**APP/M1900/W/21/3278097**  
**WITNESS STATEMENT**

**Flooding matters significant to  
The proposed quarrying activity at the Hatfield Aerodrome**

By:	John Jackson - Member of Ellenbrook Area Residents Association
Date:	17 October, 2021
Use:	Appeal <b>APP/M1900/W/21/3278097</b> (Nov. 2021) on rejection of proposed quarrying activity, Hatfield Aerodrome
Witness called by:	Ellenbrook Area Residents Association (EARA) and Smallford Residents Associations (SRA)

Ellenbrook, Hatfield and the University to the South East of the quarry

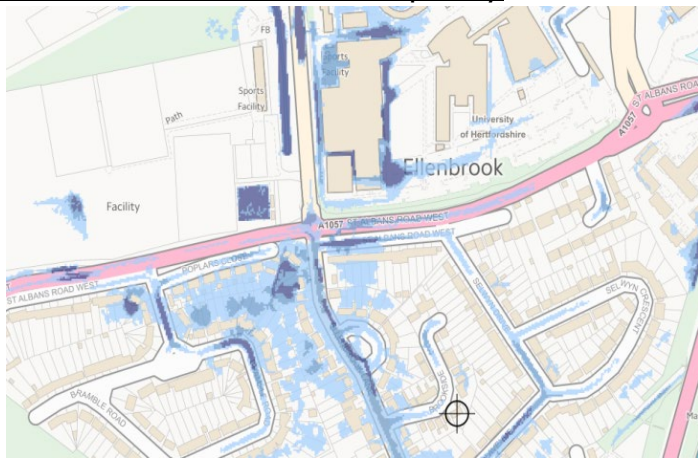
- 4.7 The EA suggest that the level of flood risk from this application will not increase, however parts of Ellenbrook and Smallford are already at the highest level of risk according to the EA flood maps for both surface and river water flooding, this is supported by the flood alert that was raised for this area on 28th August 2020. The current risk is demonstrated in the following maps.

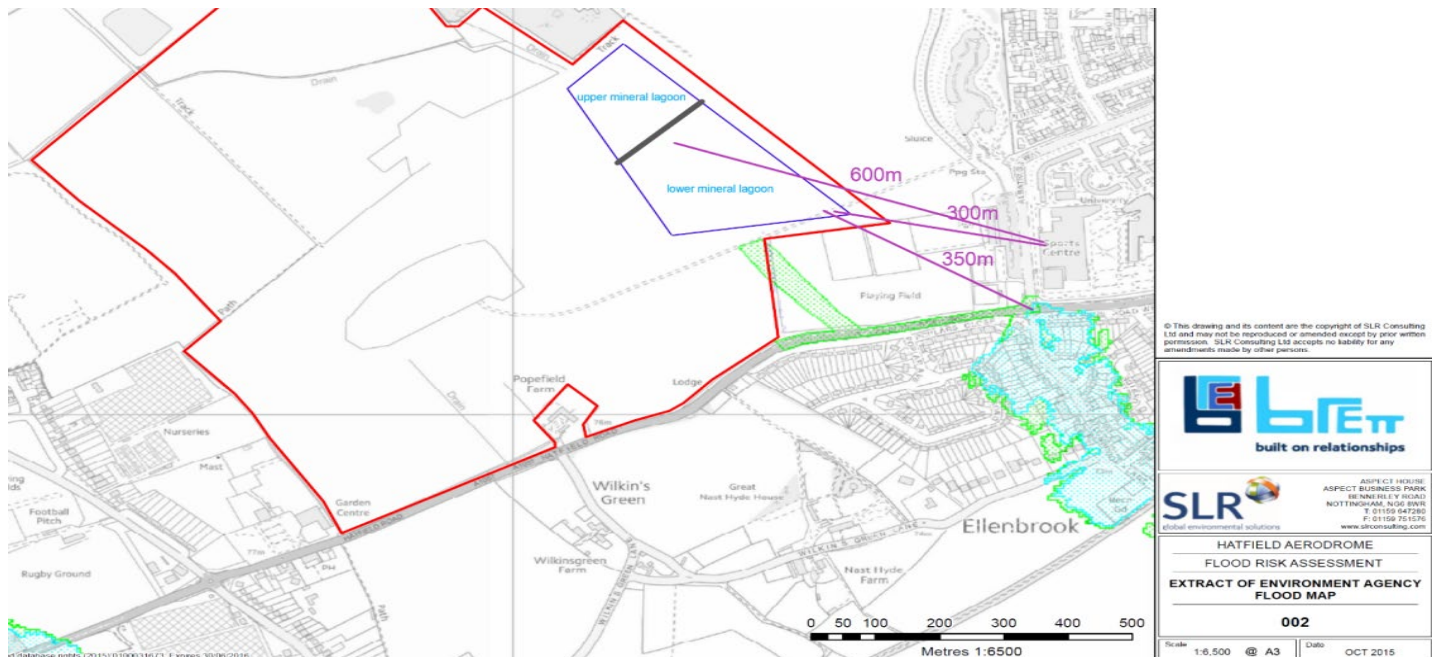
5. Flood risk to the surrounding area if the proposed lagoons overflow
- 5.1 For the quarry to operate, as the sand is dug out, so it needs to get rid of excess water. The proposal as we understand it, is that this excess water will be stored in specially constructed lagoons and the water will infiltrate back into the ground over time. The lagoons shown in blue on the map below are extremely close to the University of Hertfordshire and the residential area of Ellenbrook.
- 5.2 The quarry site is huge covering 86 hectares in total (shown in red) with a working area of 53 hectares (shown in yellow) which excludes the lagoons (blue) and plant site, as shown on the map below:

5.3 The quarry site is located very close to the University of Hertfordshire, a busy main road and housing. The land has a natural slope to the S.E and the map below shows the short distance of 300 metres to the university. It also shows how vulnerable we are to the lagoons and subsequent flooding from them.

- 5.4 We are concerned that the lagoons may overflow in the event of heavy rainfall, occurring when the discharge rate into the lagoons exceeds the infiltration leaving the lagoons. We understand from the GWMP that there is only 1m headroom available. The consequence of the lagoons exceeding their discharge rate is that SuDs drainage system will fail. This will allow surface water on the site to travel downstream towards the lowest river system, in this case the Ellenbrook and the Nast.

### 6.3 Overflow of the lagoons into the NAST brook

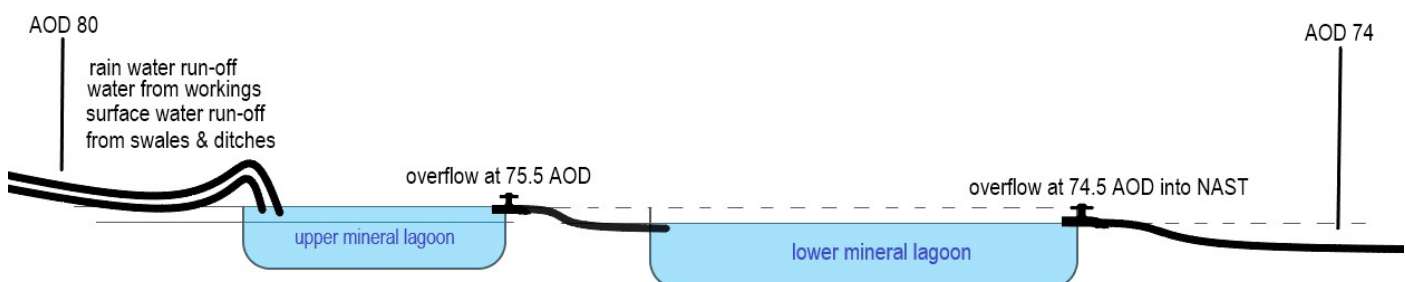
- 6.1 EARA are very concerned about the statement from the Environment Agency that changing the composition of the quarry site will not cause any direct increase in flood risk down the Ellen Brook for the reasons previously mentioned and the changing of the porosity of the ground within the dig site. It appears to us that this alone must affect the run-off and increase the risks of flooding.
- 6.2 In the event that the lagoons overflow EARA and SRA are very concerned how this may impact the flow of water into the NAST brook. There is a lack of clarity how overflow between the lagoons will work and we would like assurance that excess water will not be dumped into the Nast and therefore cause flooding in the Ellenbrook area. The following diagram illustrates how the lagoons may overflow.

- 6.4 It is not clear to us if this connection (overflow 74.5 AOD into Nast) is now or in the restoration period, either way it increases the flow to the Ellen Brook and raises the risk of flooding, now or in the future.
